APPEAL SUMMARY

Appeal ID: 15957	Project Address: 908 E Burnside St
Hearing Date: 10/11/17	Appellant Name: Kegan Flanderka
Case No.: B-018	Appellant Phone: 503.234.2945
Appeal Type: Building	Plans Examiner/Inspector: Jody Orrison
Project Type: commercial	Stories: 6 Occupancy: A-2, R-1, B, S-1 Construction Type: I-A, V-A
Building/Business Name: Jupiter Hotel	Fire Sprinklers: Yes - 100% Coverage
Appeal Involves: Erection of a new structure	LUR or Permit Application No.: 16-138295-CO
Plan Submitted Option: pdf [File 1] [File 2] [File 3]	Proposed use: Hotel

Date:	October 6, 2017	
To:	Works Partnership Architecture 811 SE Stark Street, S210 Portland, OR 97214 Sent via email	
Attention:	Kegan Flanderka Associate	
From:	David Gessert, P. E. Fire Protection Engineer	
Subject/Project:	Jupiter Hotel Hollow Structural Steel Column Fire Protection Opinion of Fire Resistance	
Job No.:	2017-50

HSS Column Fire Protection – Opinion of Fire Resistance

Detail 11, a0.03, Jupiter Hotel Typical 1Hr Rated Column Detail @ Exterior Walls

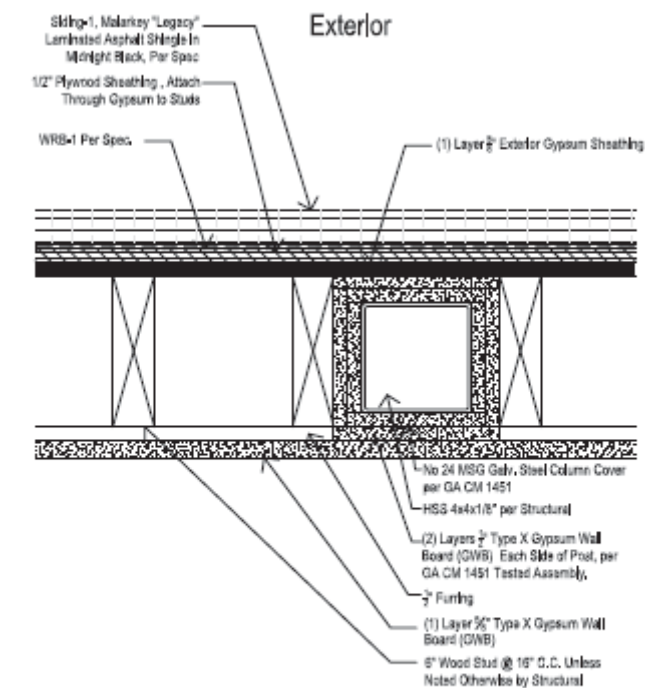
This appeal is regarding (8) HSS columns located within the exterior walls at the northwest of the building. These columns run through the upper four floors of the Type VA portion of the building and were wrapped in accordance with GA Assembly CM 1451 per OSSC 704.2 inside of a 1-Hr rated wall assembly (see attached detail). However, these HSS columns are 4" x 4" x 1/8" and not the 4" x 4" x 3/16" columns as called out in that assembly. The built assemblies meet all other conditions of CM 1451 other than the HSS thickness.

Refer to detail 11, a0.03, Jupiter Hotel, Typical 1Hr Rated Column Detail @ Exterior Walls. This detail shows a HSS 4x4x1/8" column covered on four sides with two layers of ½ inch Type X gypsum board. This entire assembly is inside an exterior wall that has one-hour fire resistance construction from both sides. See Appendix for detail.

When comparing the W/D ratios for the HSS 4x4x1/8 (0.38) and for the steel stud (0.063) we see that the HSS column will increase in temperature much slower than the steel stud when exposed to fire conditions. This is a positive attribute in the comparison and supports the conclusion that the 2 layers of gypsum board provide more than one hour of fire resistance for the HSS column.

Alternate one hour HSS column assembly with engineering analysis: Granted as proposed.

Per analysis of GA File No. WP 1204 and the W/D ratios, 2 layers of ½ inch Type X gypsum board easily provides one hour of fire resistance for the HSS column.
